Your Ref	SSD-71558711
Our Ref	NCA/6/2024
Contact	Douglas Bennett
Telephone	02 9806 5405
Email	dbennett@cityofparramatta.nsw.gov.au

COUNCIL SUBMISSION TO REQUEST FOR ADVICE ON EIS – MIXED-USE PRECINCT WITH IN-FILL AFFORDABLE HOUSING – HUGHES AVENUE, MELROSE PARK SOUTH-WEST

Appendix 1

Figure 1 BBQ facilities to be consolidated and relocated

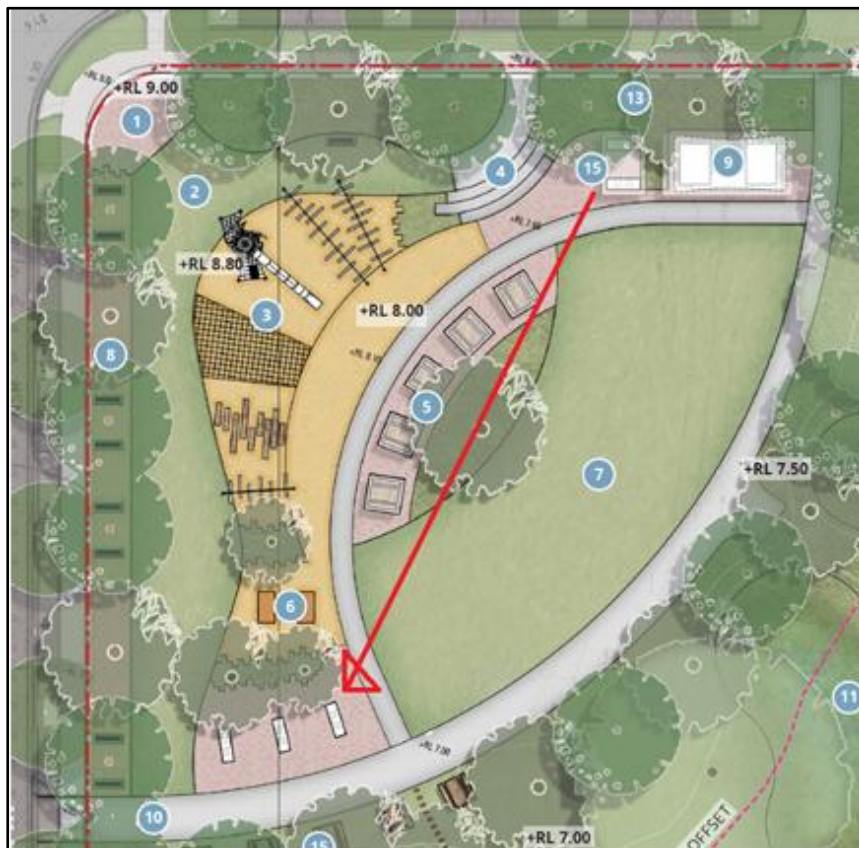
The BBQ area should be consolidated and relocated away from amenities building and include shelter(s) over the BBQ area (see figure below).

Figure 2 Trees in Western Setback

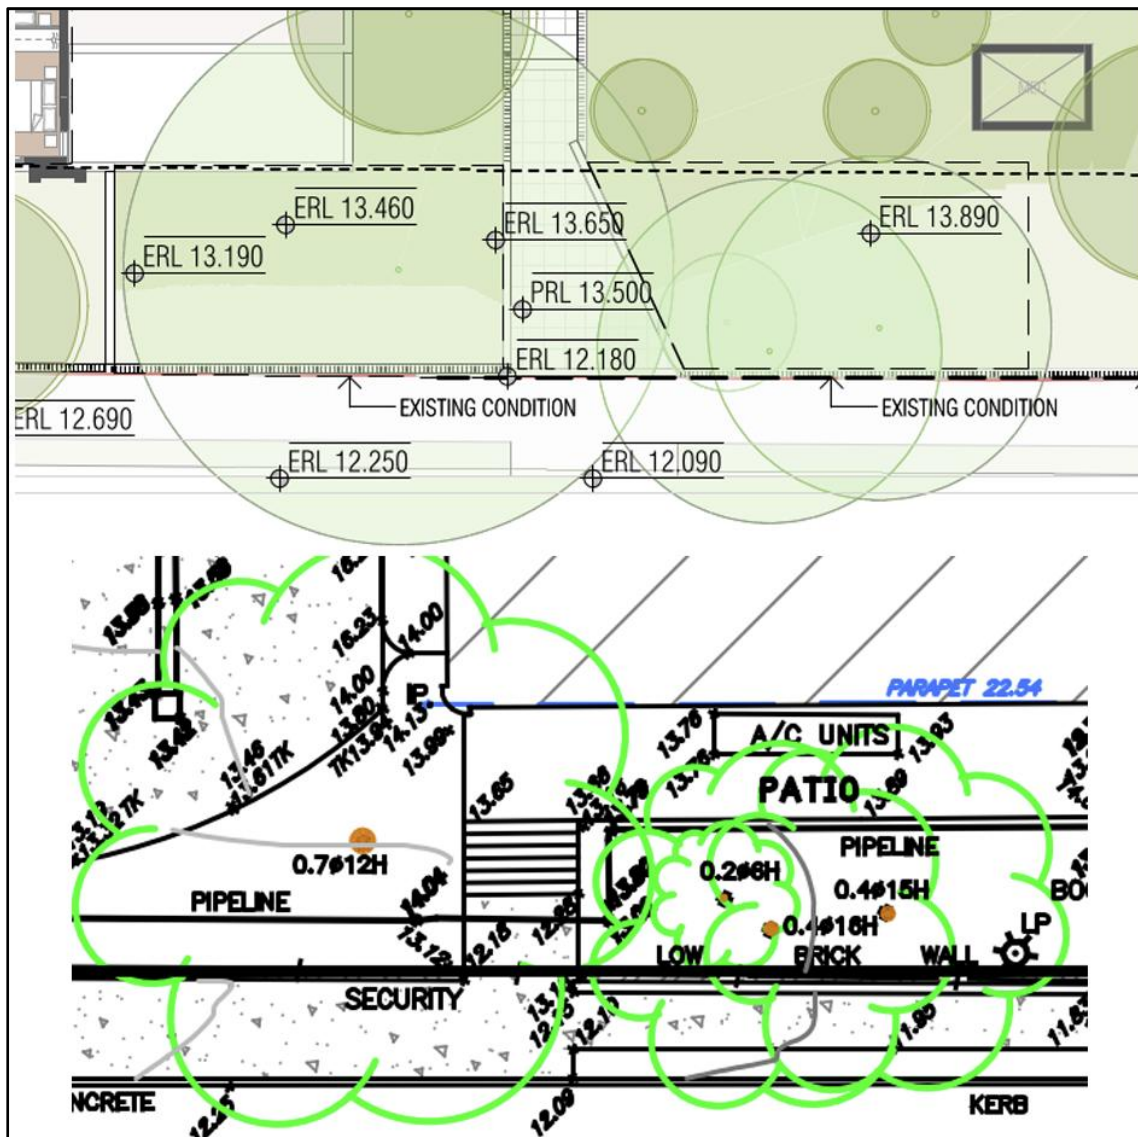
The design has been shown with a 15m setback to the north to enable retention of existing trees 24, 25, 26, 29. An elevated walkway is shown through the TPZ of these trees which is supported by Council. However, further details are required on the elevated boardwalk. The design has also tried to retain trees to the western setback 30, 33, 34, 35, 36 by showing the existing levels and treatment to be the same as existing conditions:

However, services are shown through trees 30, 33, 34, 35, and 36. In addition, additional fill is shown over the trees 33, 34, 35, 36 in section A.
